Index 711-001 Pavement Markings

PAVEMENT MARKINGS

SHEET 2 of 13

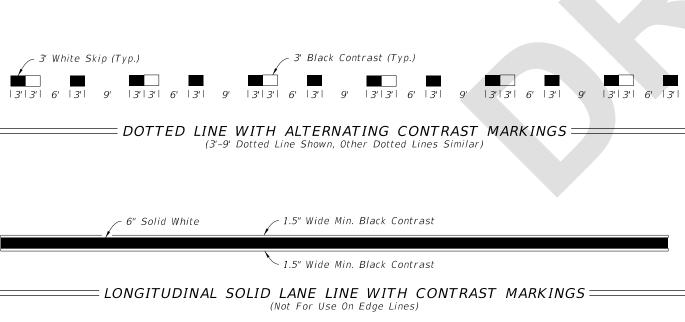
COMMENT: To coincide with changes being proposed to FDM 230, please add a detail showing the longitudinal solid lane line with contrast markings.

RESPONSE: Agree Sheet 2 will be updated.

CHANGE TO THE INDEX: Add new detail "Longitudinal Solid Lane Line with Contrast Markings" on Sheet 2
